*FY 2019-20 Standard Plans  
Update Training*

## Structures Design Office Updates

(December, 2018)

Concrete Sheet Pile Table was Changed

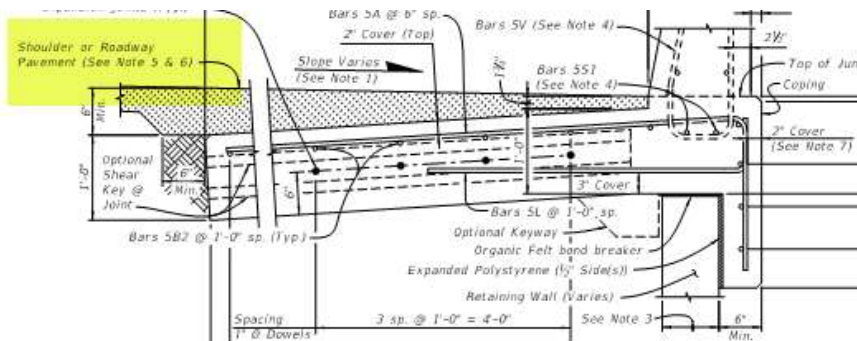
- **Index 102-200: Detour Bridge**
  - Changed Storage Facility phone number
- **Index 450 Series: 450-036 thru 450-096 Florida-I Beams**
  - Corrected Note # references in END VIEW
- **450-010 & 450-120: I Beam Notes**
  - Added Note 13 (holes in web)+
- **455-400: Precast Concrete Sheet Pile Walls**
  - Changed Table: Added Initial Jacking Force and moved Section Modulus and Prestress after Losses to SPI
- **455-440: Precast Concrete Sheet Pile Walls (corrosion resistant)**
  - Changed Table: Added Initial Jacking Force and moved Section Modulus and Prestress after Losses to SPI
  - Changed Dimension A for S4 thru S7 Bars

Strand Material	Wall Thickness	STRAND DIA. (in.)	MAXIMUM L *	n	D (in.)	TOTAL # OF STRANDS	Initial (Jacking) FORCE (Kip)
CFRP Strand	T=10 in.	0.49 (12.5mm)	26'-0"	4	4	10	28.7
		0.5 (12.7mm)	27'-0"	3	5 $\frac{1}{4}$ <sup>(2)</sup>	8	41.3
		0.6 (15.2mm)	27'-0"	3	5 $\frac{1}{2}$ <sup>(2)</sup>	8	42.7
	T=12 in.	0.49 (12.5mm)	31'-0"	5	3 $\frac{1}{2}$ <sup>(1)</sup>	12	28.7
		0.5 (12.7mm)	31'-0"	3	5 $\frac{1}{4}$ <sup>(2)</sup>	8	41.3
		0.6 (15.2mm)	31'-0"	3	5 $\frac{1}{2}$ <sup>(2)</sup>	8	42.7
HSSS Strand	T=10 in.	0.5 (12.7mm)	27'-0"	5	3 $\frac{1}{2}$ <sup>(1)</sup>	12	25.7
		0.6 (15.2mm)	26'-0"	3	5 $\frac{1}{4}$ <sup>(2)</sup>	8	36.5
	T=12 in.	0.5 (12.7mm)	32'-0"	6	2 $\frac{3}{4}$ <sup>(3)</sup>	14	25.7
		0.6 (15.2mm)	32'-0"	4	4	10	36.5

## • Index 462-002 & 462-003: Post Tensioning Details

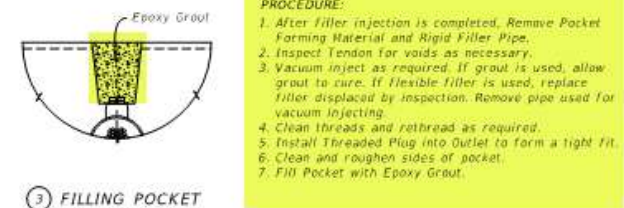
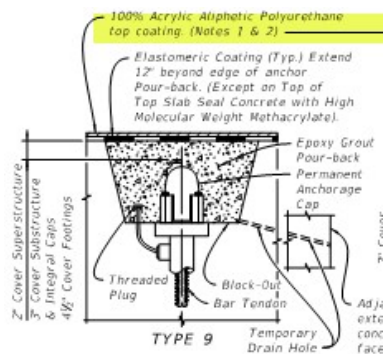
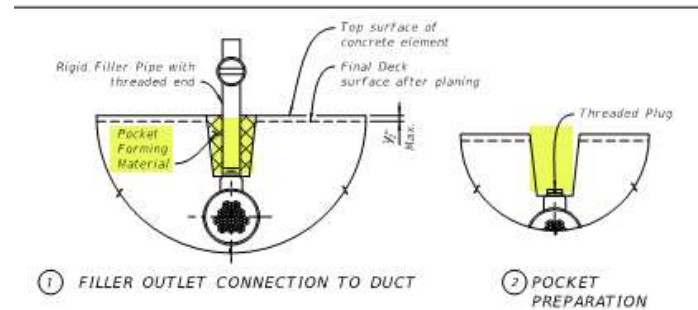
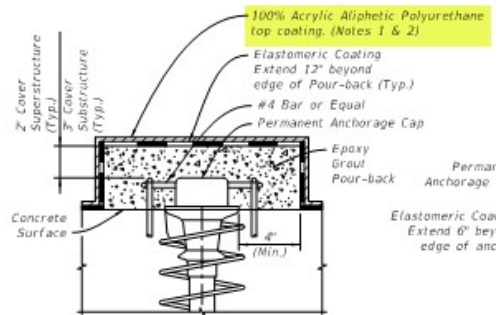
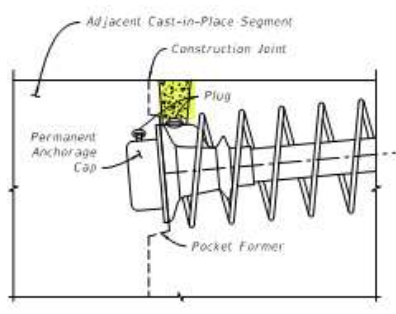
- Added Pockets around Plugs for constructability
- Added polyurethane top coating to drawings (specification requirement)

## Index 521-660: Light Pole Pedestal - Bridge

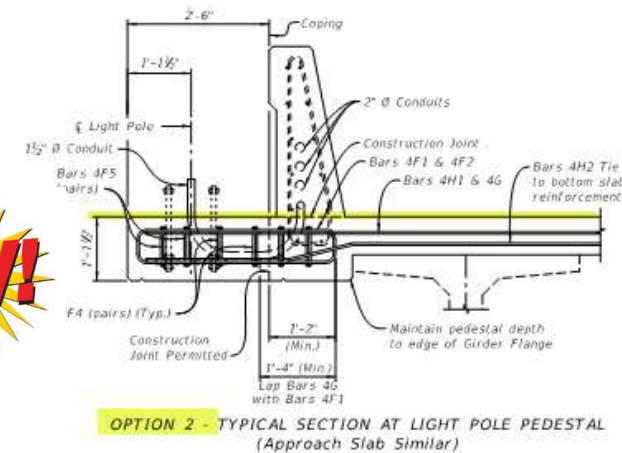
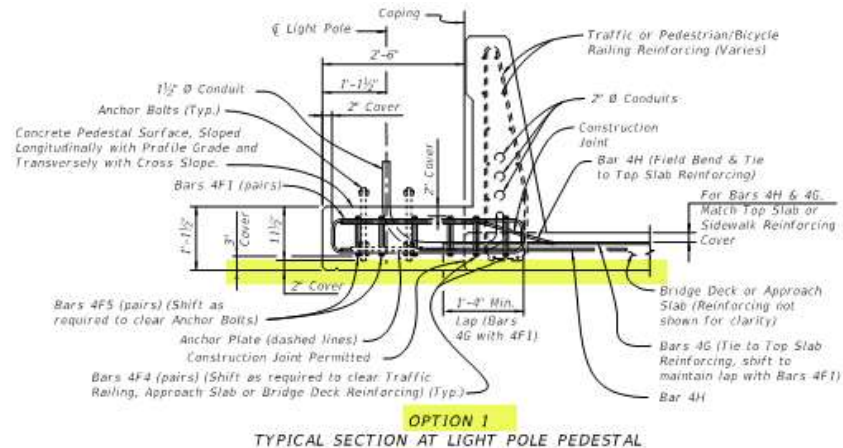
Added Options for forming pedestal when deck thickness is less than 1'-5"

- Option 1 is old design with bottom of deck and bottom of pedestal at the same level
- Option 2 is new (added sheet). The top of the pedestal is at the same level as the deck with the bottom of the pedestal below the bottom of the deck level
